**NOTICE OF A TYPE II<sub>x</sub> DECISION ON A PROPOSAL IN YOUR NEIGHBORHOOD**

**CASE FILE NUMBER: LU 08-109767 LDS AD**

**Case Type:** LDS AD (Land Division [Subdivision] with an Adjustment)

CASE NO. 08-109767-LOS AD  
EXHIBIT C-3

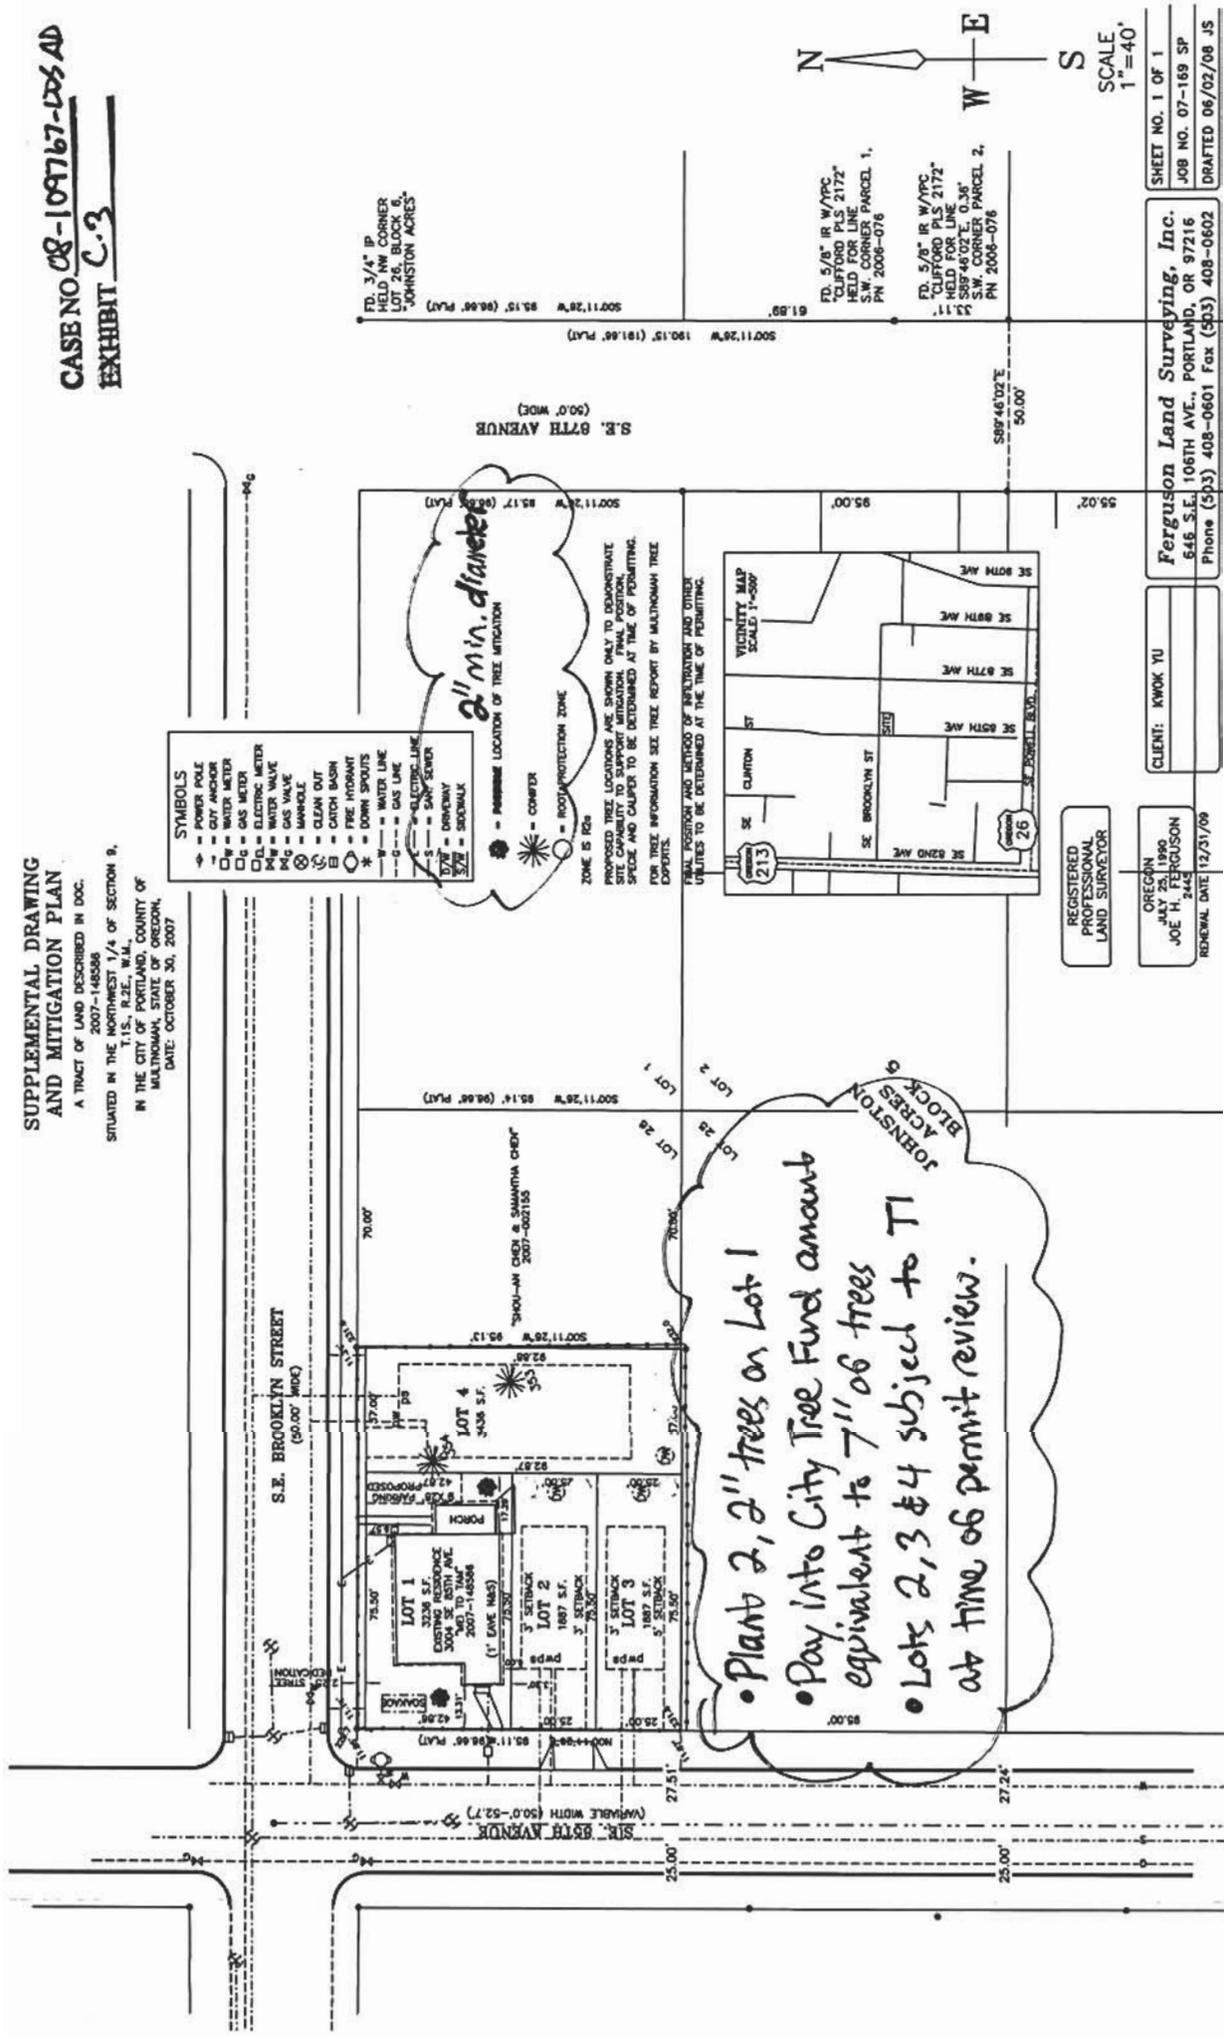
As an alternative, the applicant will be required to plant two 2-inch trees (4 inches total) on Lot 1 and contribute payment of an amount equivalent to 7-inches of new trees into the City Tree Fund prior to final plat approval. Lots 2, 3 and 4 will be subject to the T1 tree-planting requirement at the time of building permit review.

7. A minimum of two 2-inch trees to be planted on Lot 1 as shown on the attached Tree Mitigation Plan (Exhibit C.3), and payment contributed an amount equivalent to 7-inches of trees into the City's Tree Fund, prior to final plat approval. A Zoning Permit must be obtained, and receive final inspection approval verifying that these trees have been planted. In addition, a receipt must be submitted demonstrating payment into the tree fund. Payment must be made to the Bureau of Development Services, who administer the fund for the Parks Bureau.

- Plant 2, 2" trees on Lot 1
- Pay into City Tree Fund amount equivalent to 7" of trees
- Lots 2, 3 & 4 subject to T1 at time of permit review.
